File Number	PLSUP-2504-0049		Contact	Natalie Lavenstein, nlavenstein@duluthmn.gov	
Type	Special Use Permit – Daycare Facility		Planning Commission Date		May 13, 2025
Deadline for Action	Application Date		April 2, 2025	60 Days	June 1, 2025
	Date Extension Letter Mailed		April 18, 2025	120 Days	July 31, 2025
Location of Subject		404 E 5 th St			
Applicant	One Roof Community Housing		Contact	Debbie Freedman	
Agent	St Mary’s Medical Center		Contact	Dan Cebelinski	
Agent	Benedictine Sisters Benevolent ASSN		Contact	Sister Beverly Raway	
Legal Description		010-1010-01710, 010-1010-01800, 010-1010-01815, 010-1010-01700, 010-1010-01760			
Site Visit Date		April 29, 2025	Sign Notice Date		April 29, 2025
Neighbor Letter Date		April 18, 2025	Number of Letters Sent		56

PLSUP-2504-0049
Special Use Permit
404 E 5th St

PROJECT NAME:
BRAE VIEW APARTMENTS

LANDSCAPE AND
TREE PLAN

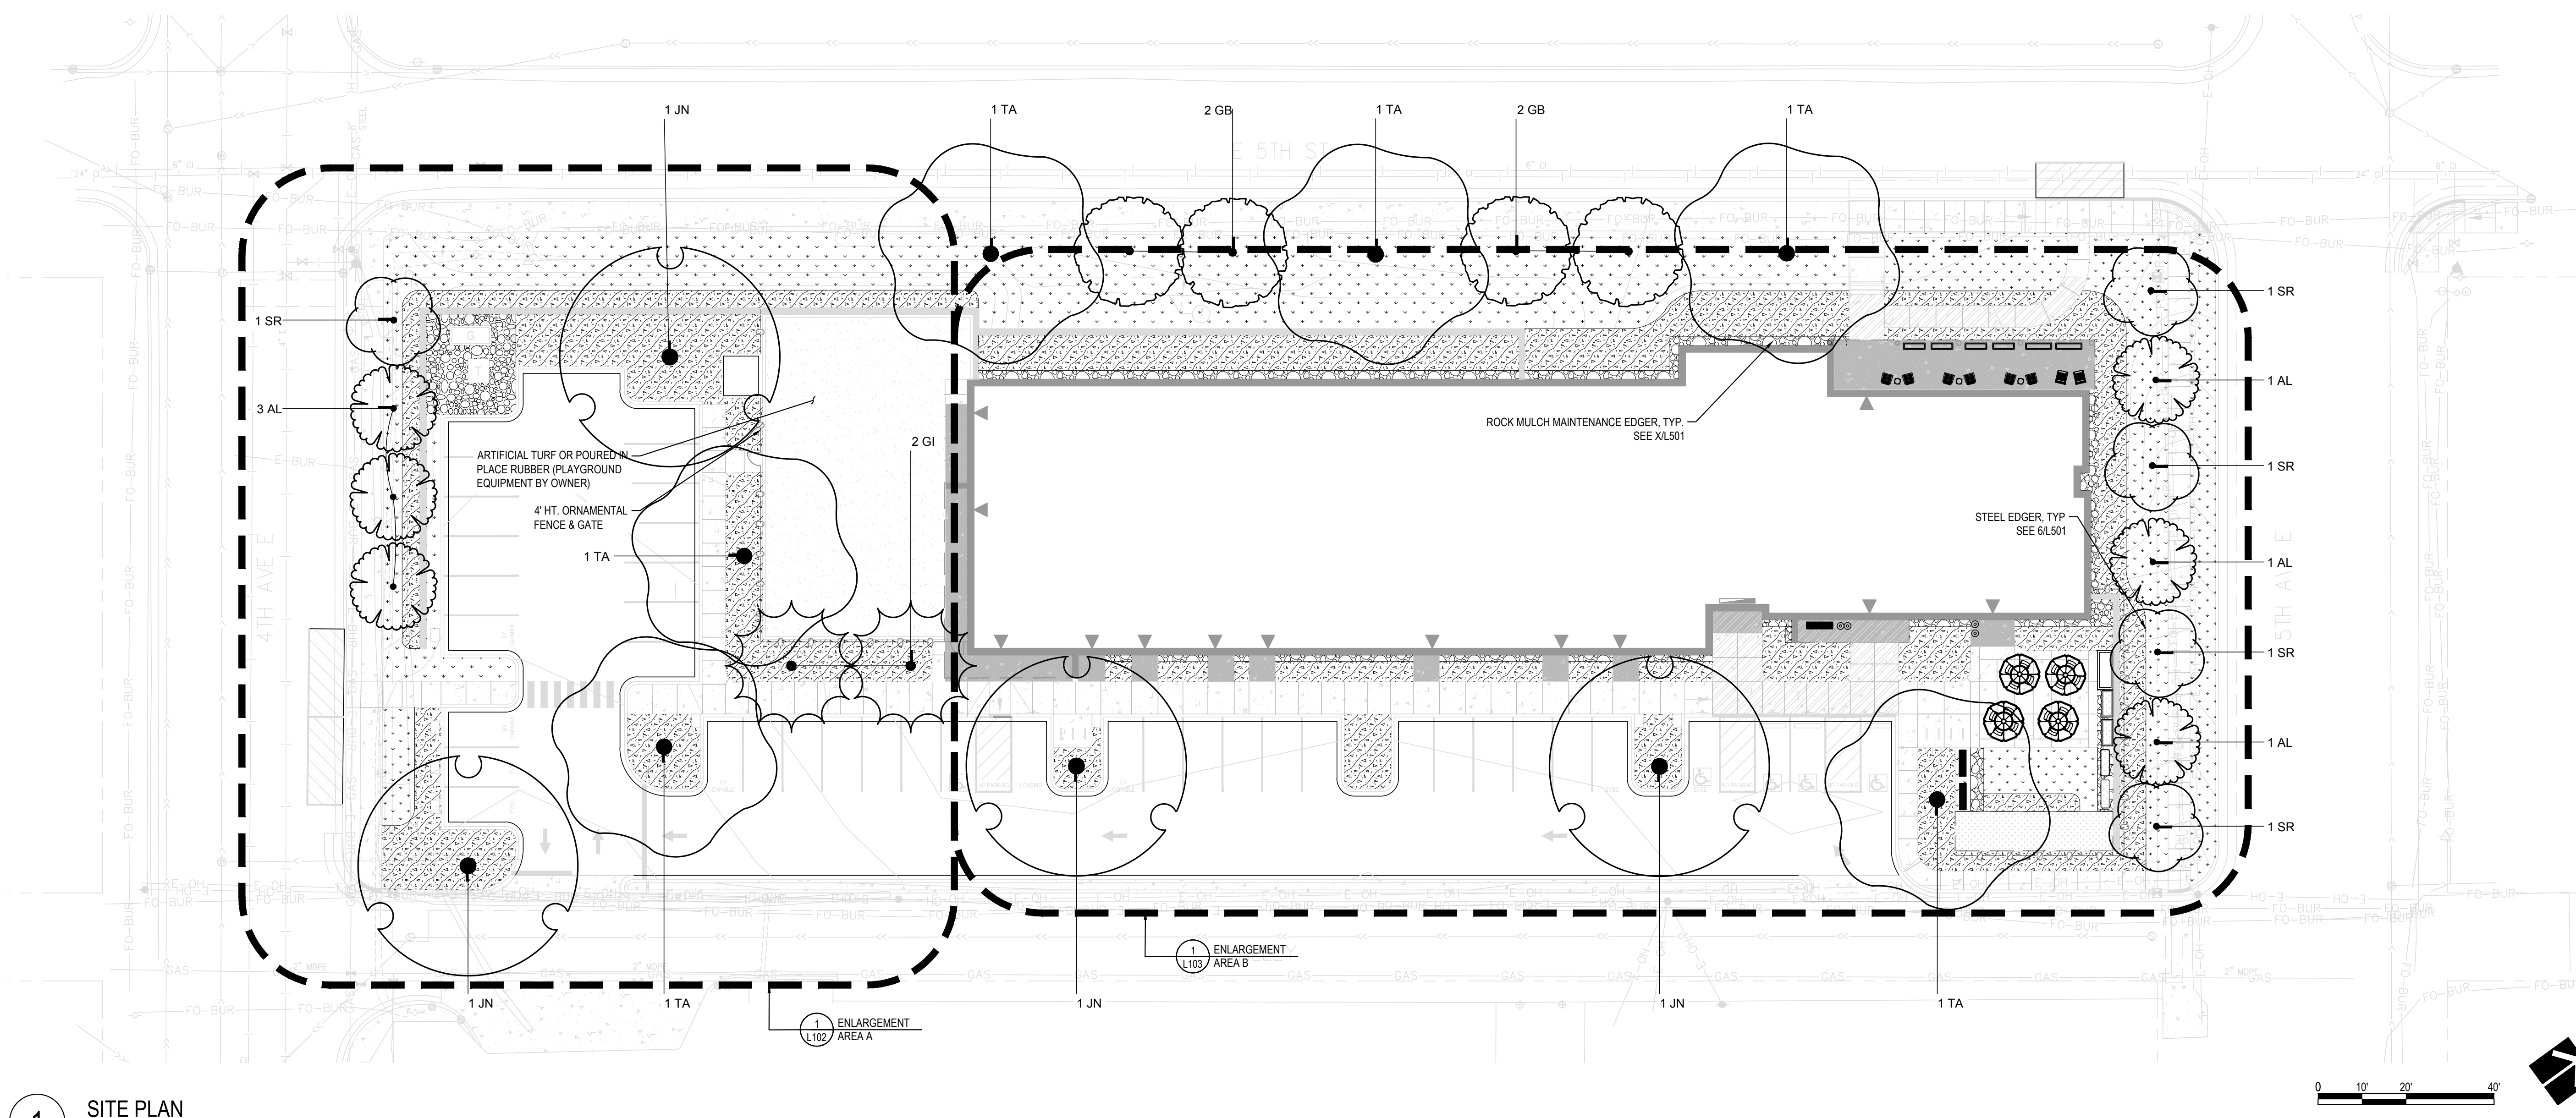
- 4) UDC Sec. 50-25 (Landscaping and Tree Preservation). The daycare is proposed to be located in the Brae View apartment building, and will have shared parking and site use. Preliminary plans for Brae View show all landscape requirements will be met. Landscaping will be confirmed prior to Brae View receiving the building permit for the site.
